ADDENDUM NO. 2
(4 Pages of text, 10 pages of attachments / Total = 14 Pages)

TO THE DRAWINGS, SPECIFICATIONS AND CONTRACT DOCUMENTS FOR:

Fairfield County
Sheridan Center Renovations - Phase1
Comm. No. 2024149.01

A101

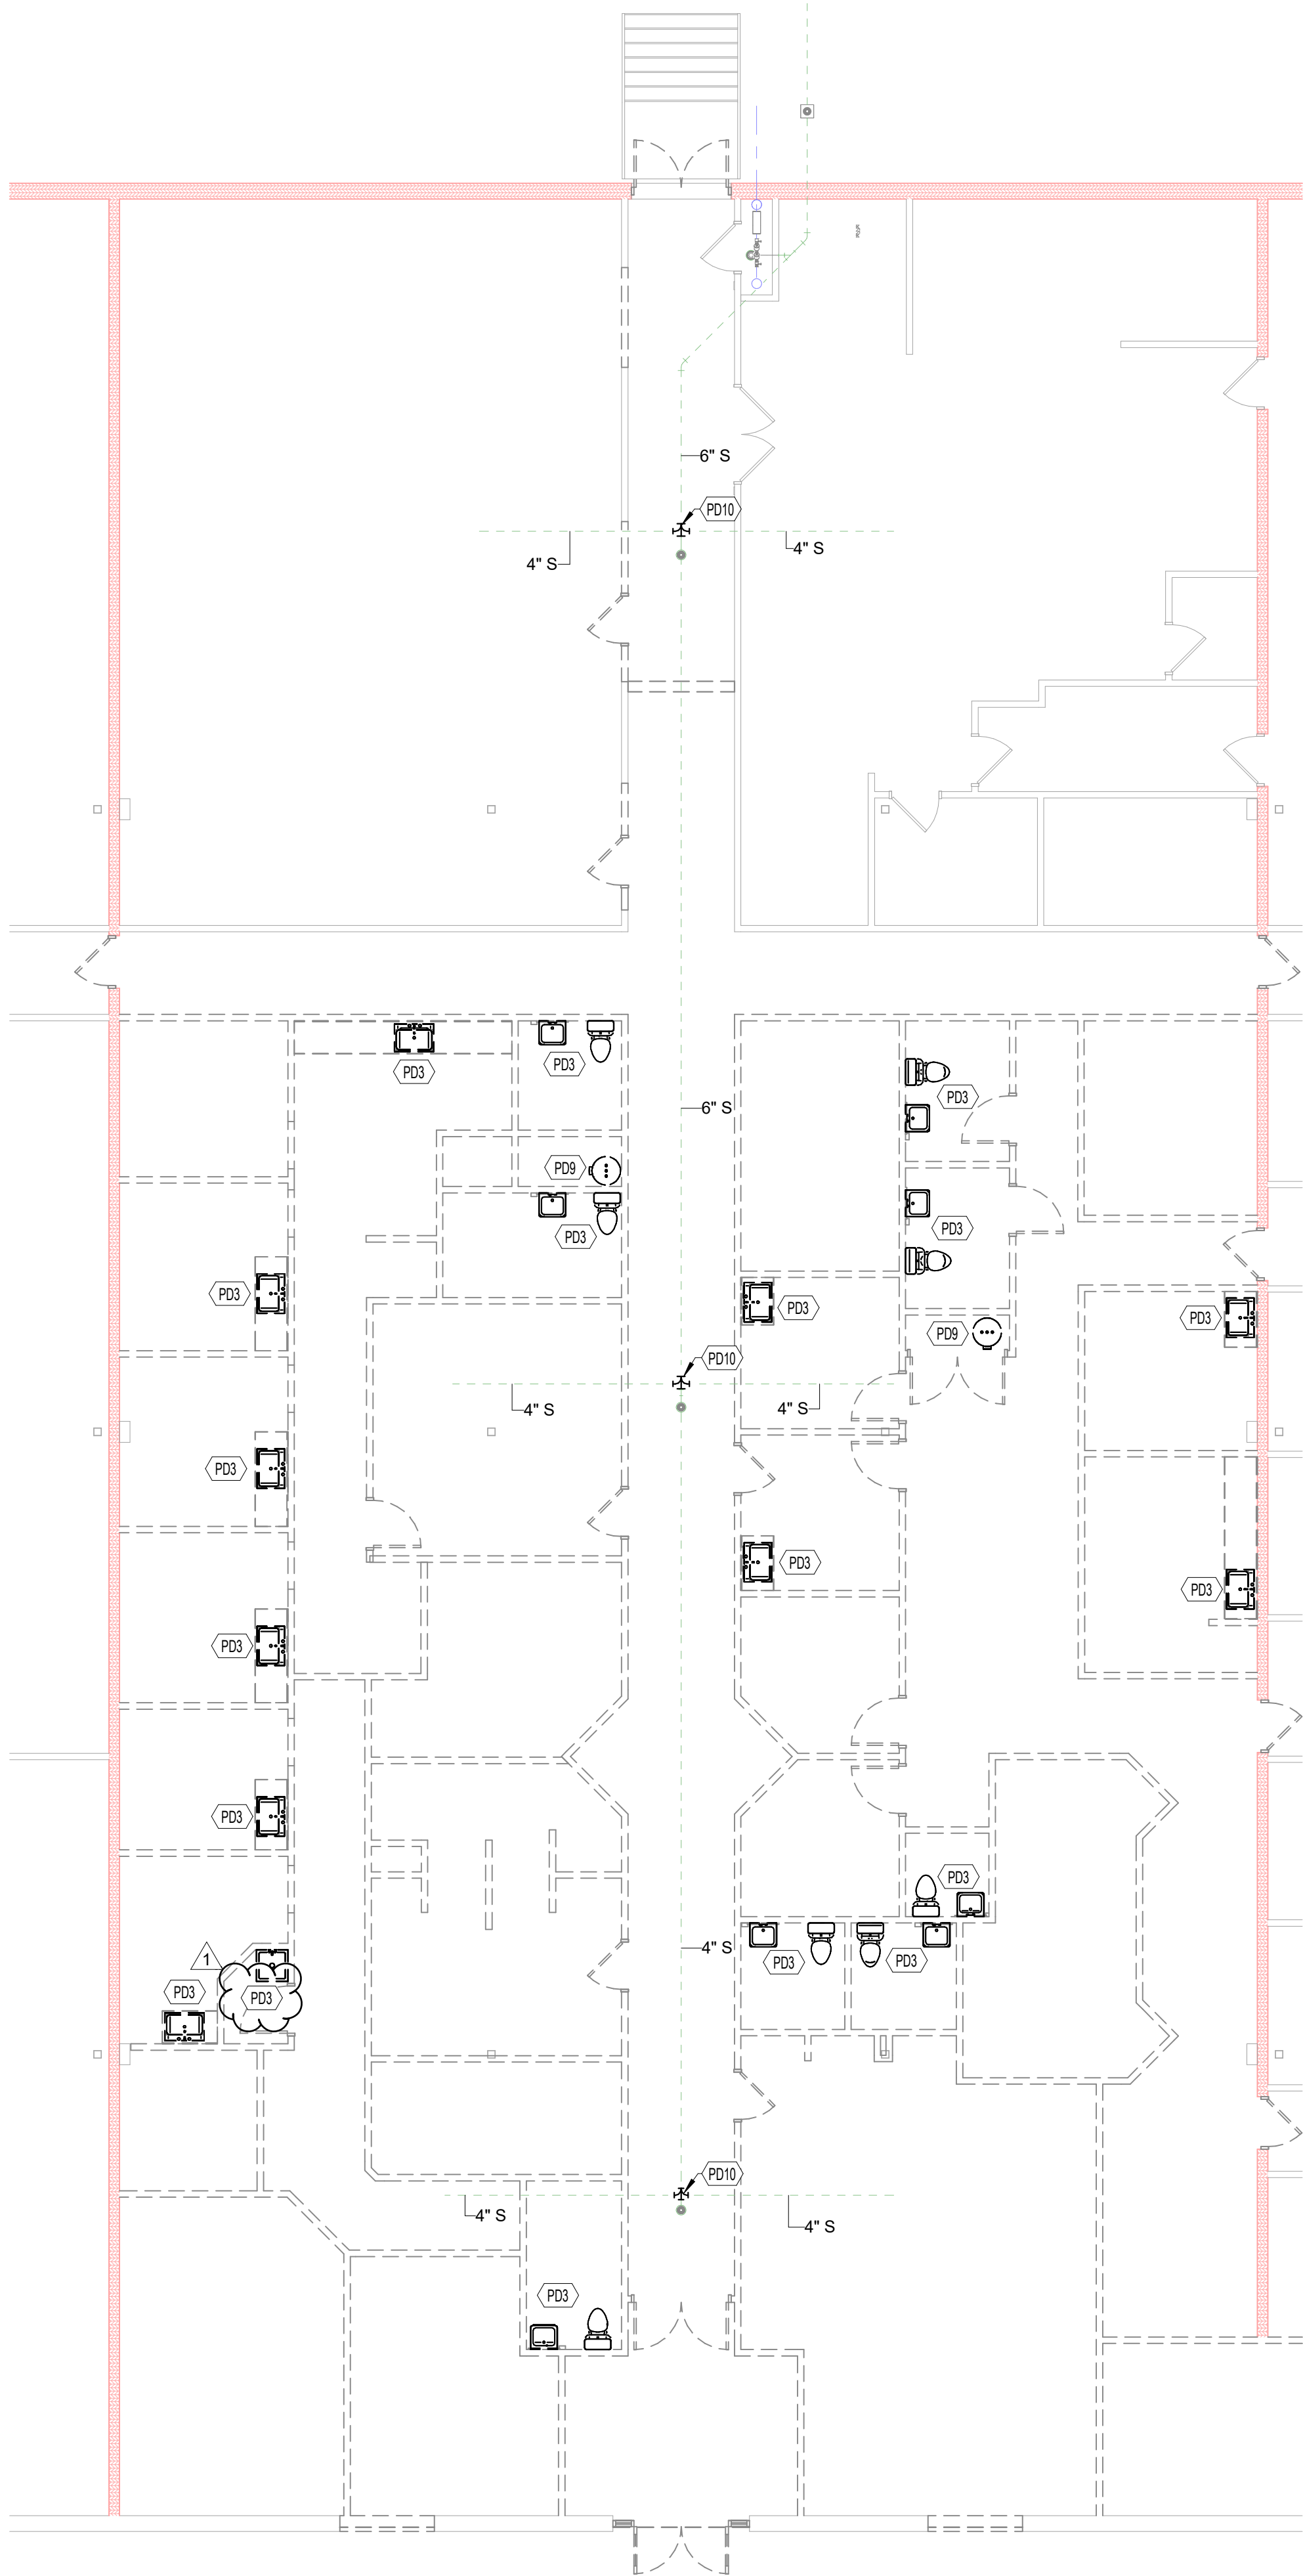
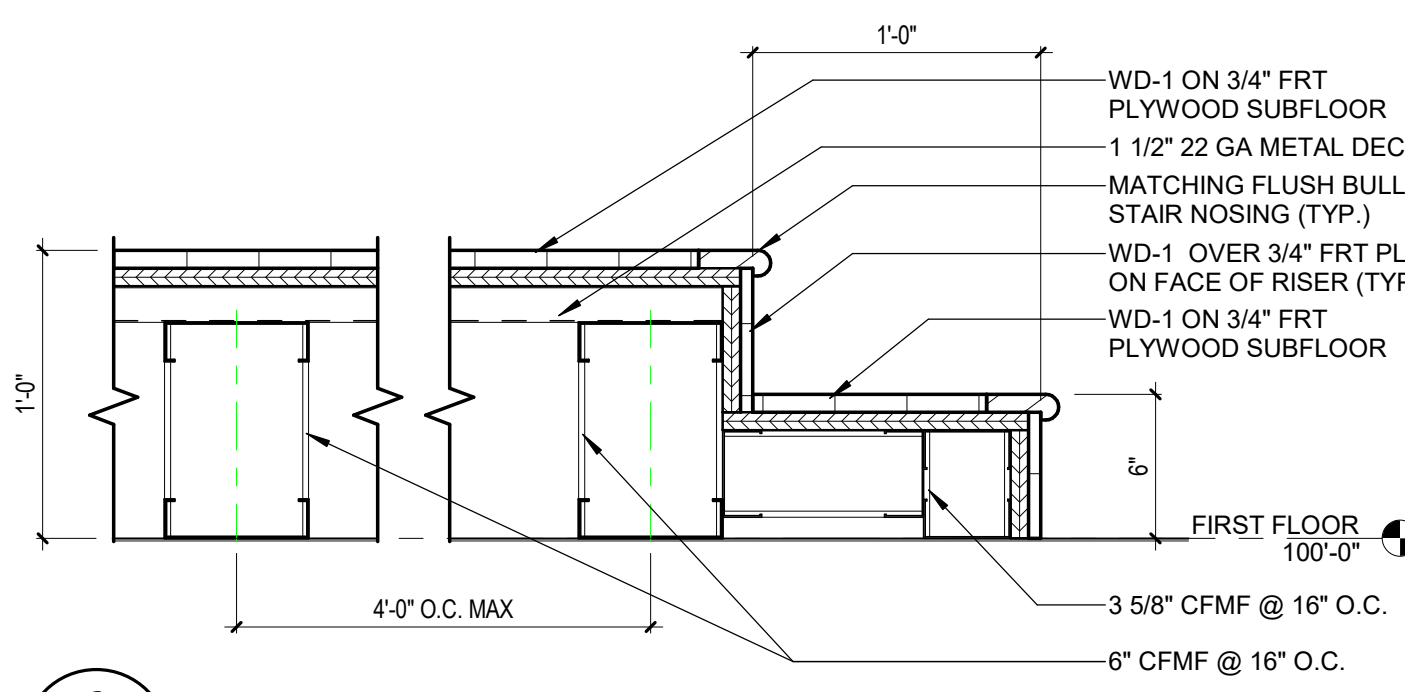
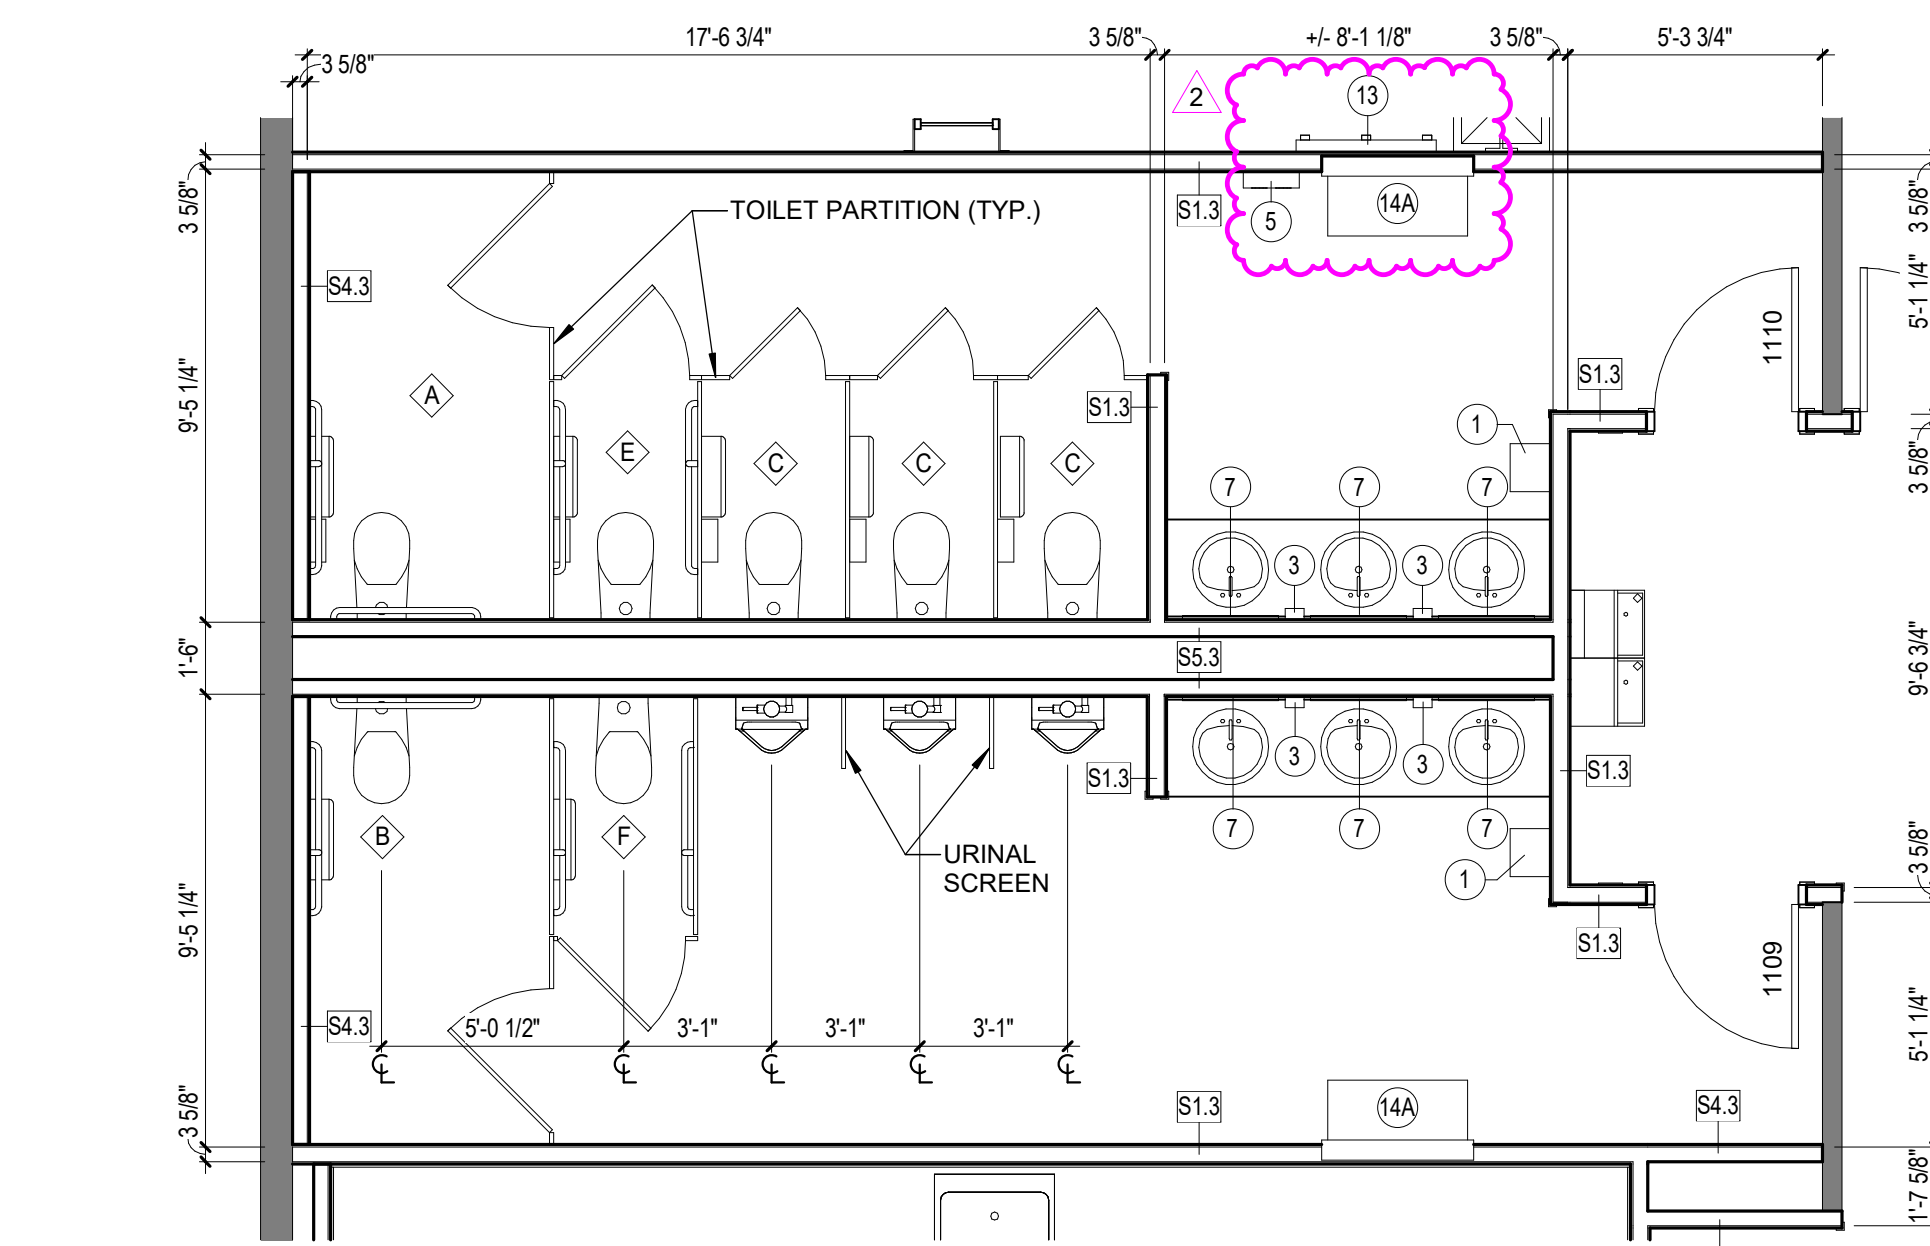
5. Tissue Dispensers (2 & 2a)- Specs call out the same product. Drawing shows different designs.
Answer: Refer to attached Sheet A101. The drawings have been updated to match the specifications. TBA Item 2A has been removed from the drawings.

7. Mop & Broom (TBA-13) and Robe Hook (TBA-17) are shown in the specs but no where listed on drawings.

- 1. **SHEET G101 – Code Data Sheet (Re-Issued):**
 - A. Added (4) Fire Extinguisher Cabinets. Provide one fire extinguisher per cabinet.
- 2. **SHEET A101 – First Floor Plan (Re-Issued):**

- A. Updated Toilet and Bath Accessories.
- 3. **SHEET P010 – First Floor Plumbing Demolition Plan (New):**
 - A. Issue new sheet to clarify plumbing demolition showing locations where underground sanitary to be capped below floor.

Answer: Refer to attached Sheet A101. Mop and Broom Holder has been added in Storage 1112. Coordinate final location with owner. Robe Hook shown in the specifications for reference only.

P010

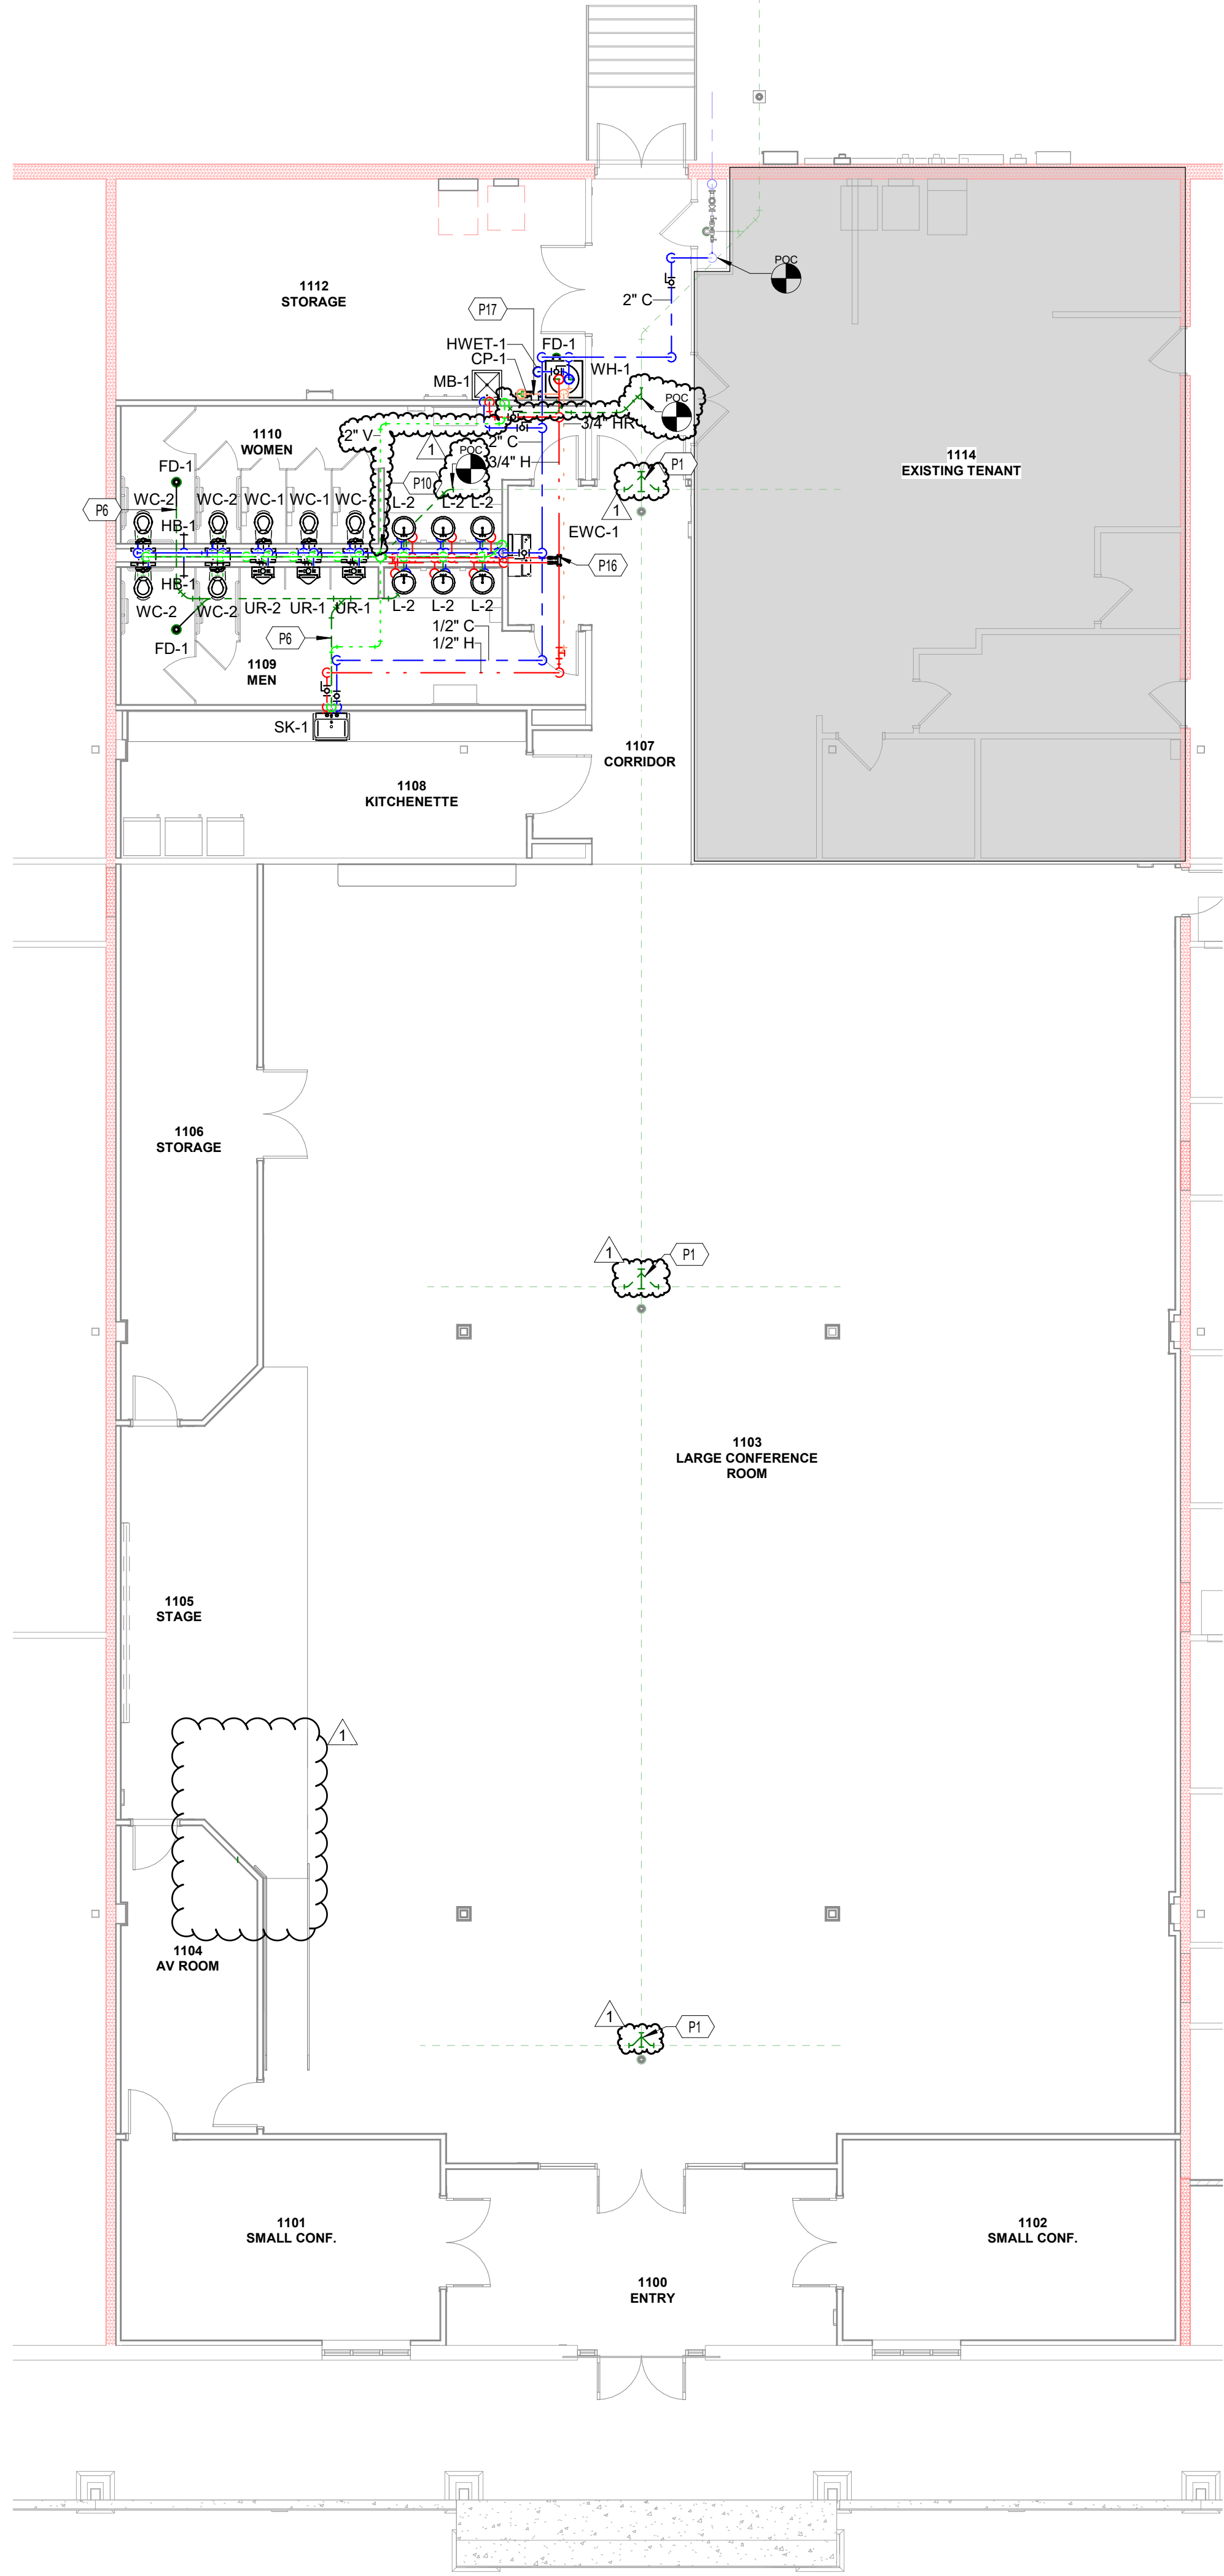
1. Please specify the depths and locations of the existing sanitary piping to be removed. This information is critical for determining the extent of slab removal and replacement.

- B. Remove Keynote PD11 and replace with PD3
- 4. **SHEET P100 – Plumbing First Floor Plan (Re-Issued):**
 - A. Plumbing Roof Plan View 2/P100 added to show gas pipe scope.

Answer: The underground sanitary depths are unknown. A plumbing demolition sheet P010 is added to identify locations where plumbing fixtures are demolished and where sanitary needs to be capped below the floor.
